SUBJECT: U.S. NUCLEAR REGULATORY COMMISSION CONCURRENCE OF THE
GROUND WATER COMPLIANCE ACTION PLAN AND APPLICATION FOR
ALTERNATE CONCENTRATION LIMITS FOR THE CANONSBURG,
PENNSYLVANIA, UMTRA SITE

**TECHNICAL EVALUATION REPORT
CANONSBURG GROUNDWATER COMPLIANCE ACTION PLAN AND
ALTERNATE CONCENTRATION LIMIT APPLICATION**

DATE: December 30, 1999

FACILITY: Canonsburg, PA

FIGURE 2
LOCATIONS OF MONITOR WELLS AND SURFACE WATER SAMPLING
CANONSBURG, PENNSYLVANIA, DISPOSAL SITE

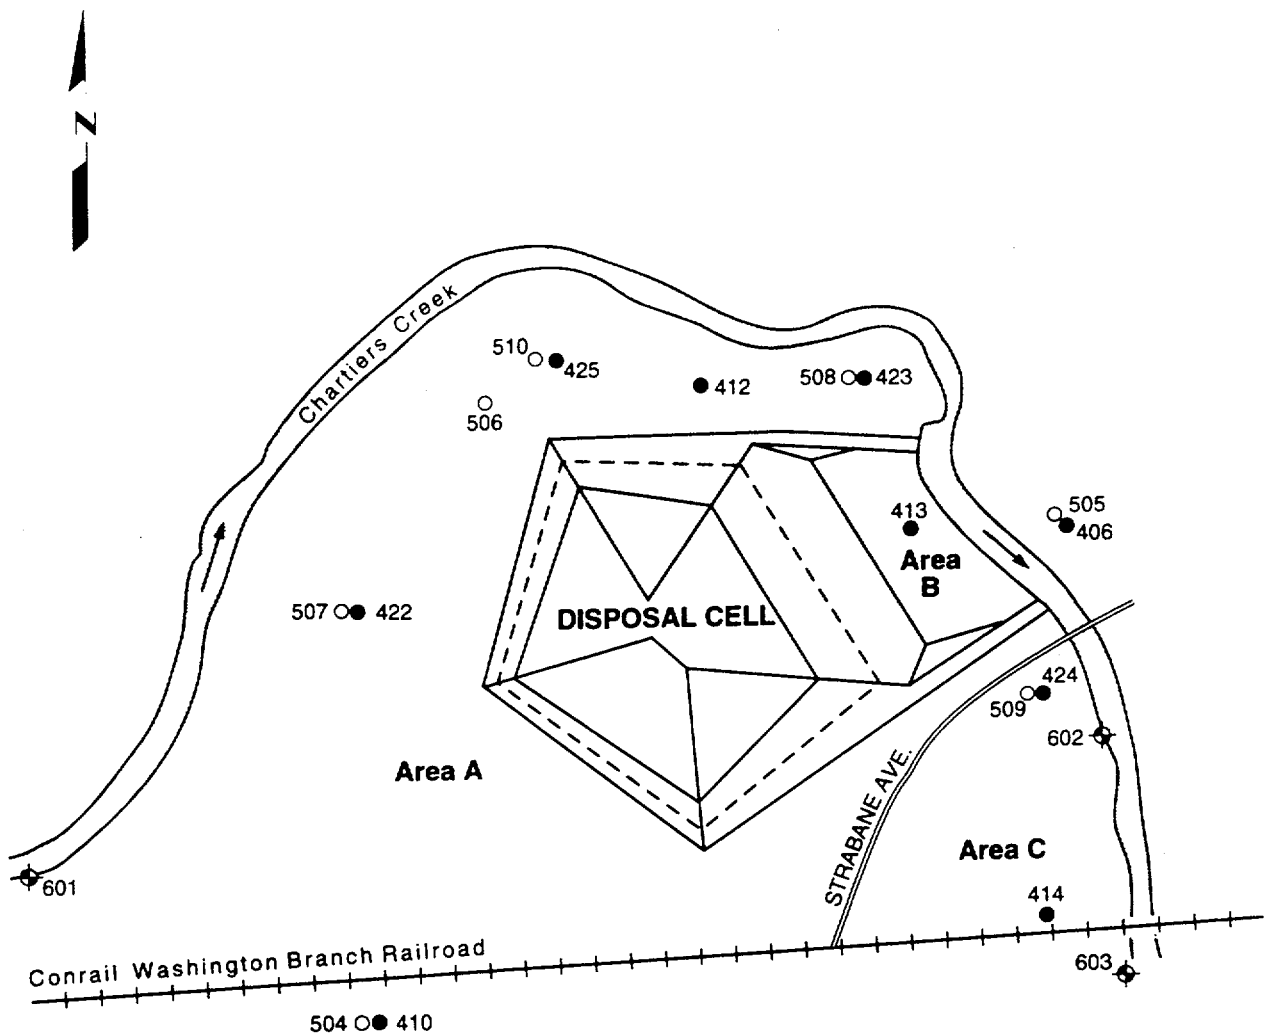
flow under Chartiers Creek and migrate towards water supply wells, DOE will include monitoring well 406 in the monitoring program.

- The surficial aquifer is assumed to be connected to Chartiers Creek. The stream is assumed to be gaining, that is all groundwater discharging into the stream. The stream is assumed to be a sink for all groundwater flowing toward it in the model. Monitoring well 406 was added to verify that this assumption is correct as requested by the NRC.
- A steady-state flow system is assumed.
- The unconfined aquifer is assumed to be homogeneous.
- Sources are assumed to be a single source.

As a result of comments from the NRC, DOE evaluated the use of a permeable reactive treatment (PeRT) wall. DOE is using this innovative technology in Monticello, Utah, where uranium has been reduced to non-detectable levels. The wall would be placed between wells 412 and 414, down-gradient of the plume. Zero valent iron (ZVI) would be used to precipitate heavy metals from the ground water as it migrates through the wall. COCs uranium and molybdenum could be effectively reduced using this technology, however, manganese may increase because it is a trace element of ZVI. Uranium would precipitate as the mineral uraninite if the oxidation state of the aqueous solution is lowered sufficiently, as occurs with ZVI. The cost for this technology was estimated to be \$1,700,000 and would, therefore, not be cost effective. The high cost of this technology is mainly due to costly materials (ZVI).
